**Re: *In re: City of Attleboro, MA Department of  
Wastewater, Government Center,  
77 Park Street, Attleboro, MA 02703  
NPDES Permit No. MA 0100595***

**PETITION FOR REVIEW**

Fig. 7. Freshwater inflow versus flushing time of the Seekonk River from all estimates obtained in this study (WW dye—Wet Weather dye data, WW Box M.—Wet Weather box model, Spray and Sinbadd cruises).

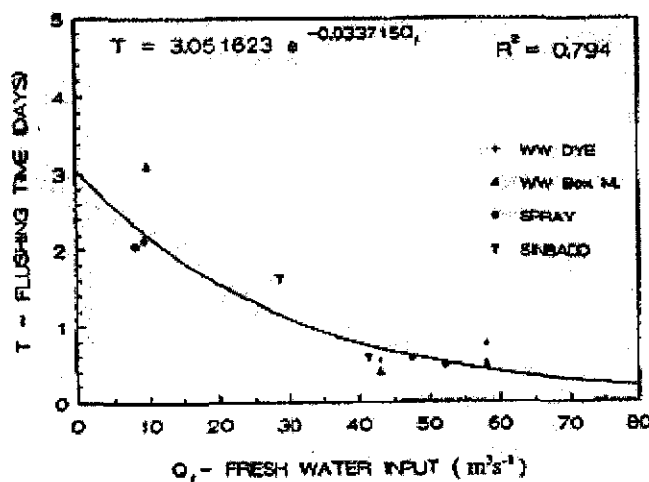
The Seekonk River, which is the basis for the Permit's nitrogen loadings<sup>4</sup> has a flushing time of 3.5 days with no freshwater inflow, as demonstrated in the studies cited by RIDEM (Asselin). At other times, the flushing times in the Seekonk are far faster.<sup>5</sup> Region 1 was therefore wrong to reject the City's comment about flushing in the Seekonk River by stating that "the flushing time in the Providence River" "would be slower than 3.5 days" during high temperature, low flow, conditions during summer. RTC, p. 35.
